November 24, 2015

Reference No. 038443

**Re:     Summary of Vapor Intrusion Sampling Results  
S&J Precision – Building 12  
South Dayton Dump and Landfill Site, Moraine, Ohio**

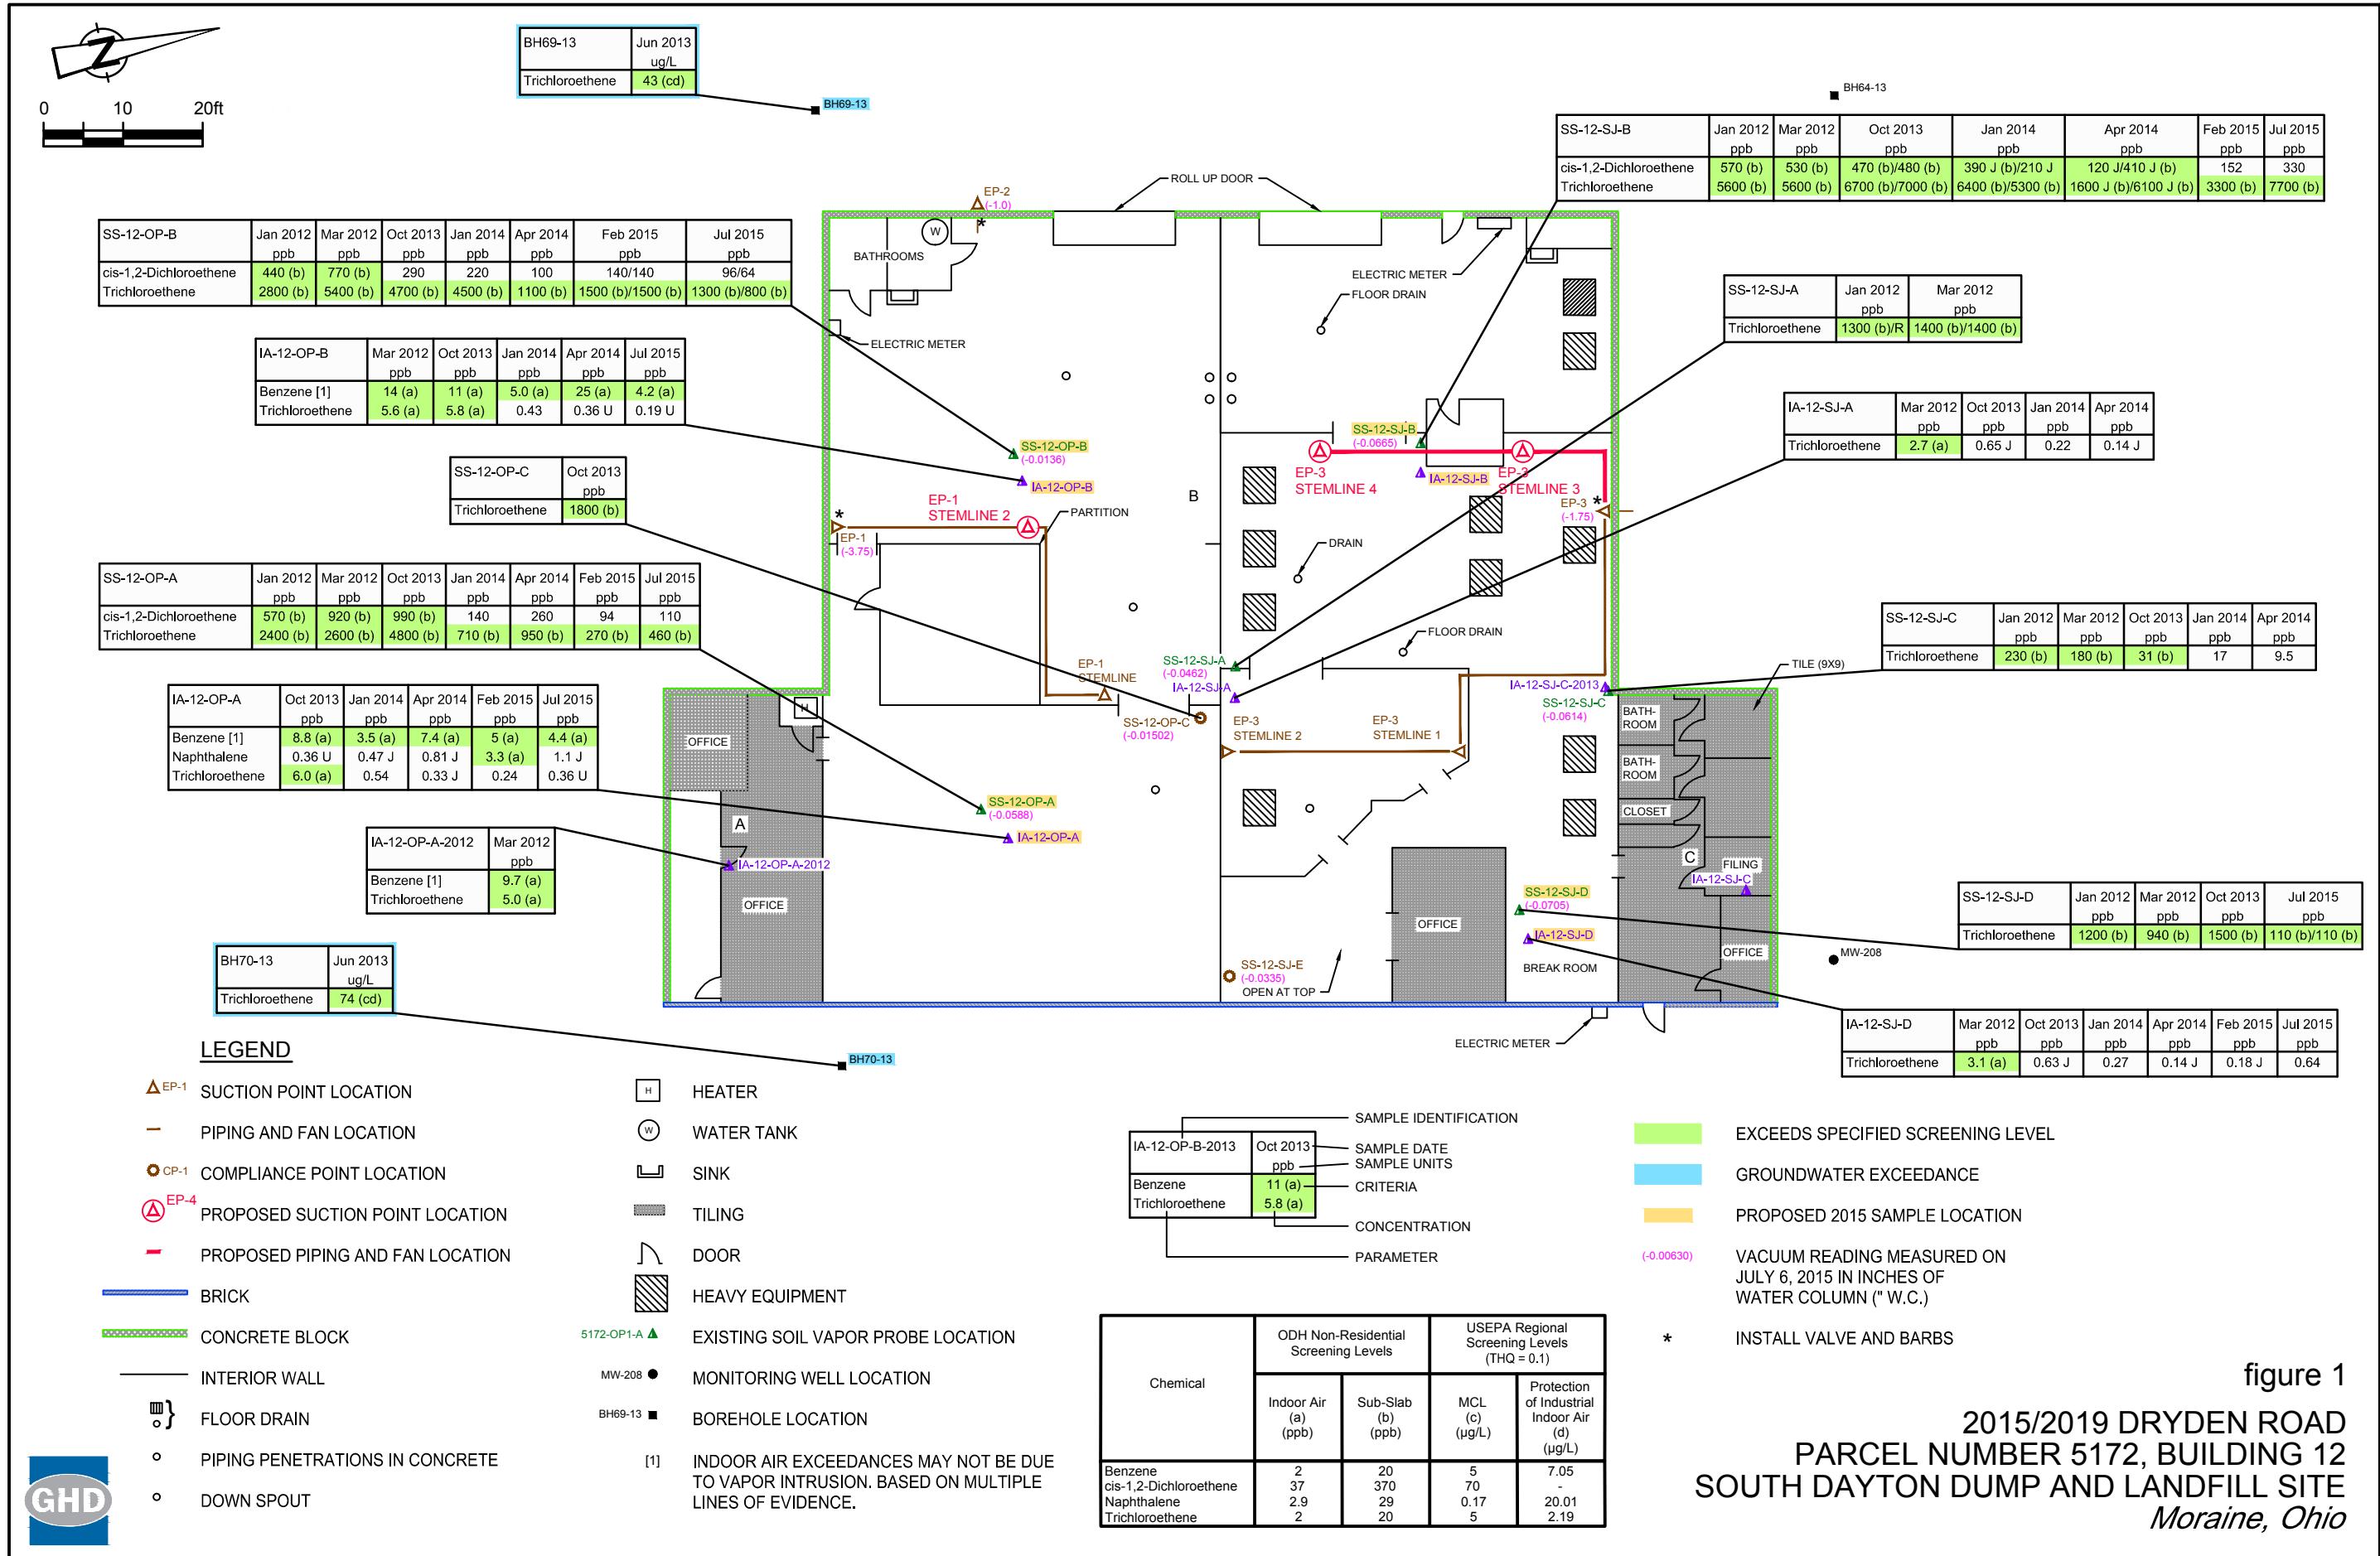
Based on the TCE SS soil vapor sample exceedances of ODH SS screening levels (AF=10 and AF=33), continued operation of the SSDS for Building 12 is required and system upgrades should be considered.

As presented on Figure 1, U.S. EPA and GHD propose to install two additional stemlines (EP-3 stemline 3 and EP-3 stemline 4) in S&J Precision in the vicinity of SS-12-SJ-B in order to further address the TCE exceedances at that location. GHD will collect samples 60 days following the proposed system modifications to monitor concentrations.

GHD will install valves at all extraction points, where possible, to control and reduce the amount of vacuum applied to the sub-slab. GHD notes that it may not be feasible to install valves at all suction points due to the existing system configuration.
